APPLICATION NO.	FILING DATE	FIRST NAMED INVENTOR	ATTORNEY DOCKET NO.	CONFIRMATION NO.
09/897,236	07/02/2001	Eiji Nakashio	09792909-5084	8218

Office Action Summary

Application No. 09/897,236	Applicant(s) NAKASHIO ET AL.	
Examiner A. J. HEINZ	Art Unit 2653

Addendum B

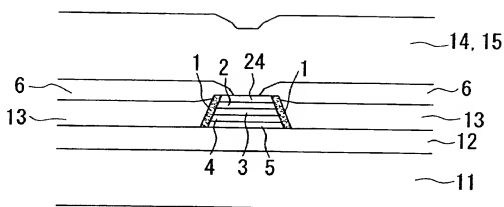
Re claim 16, see structure as shown in Addendum B.
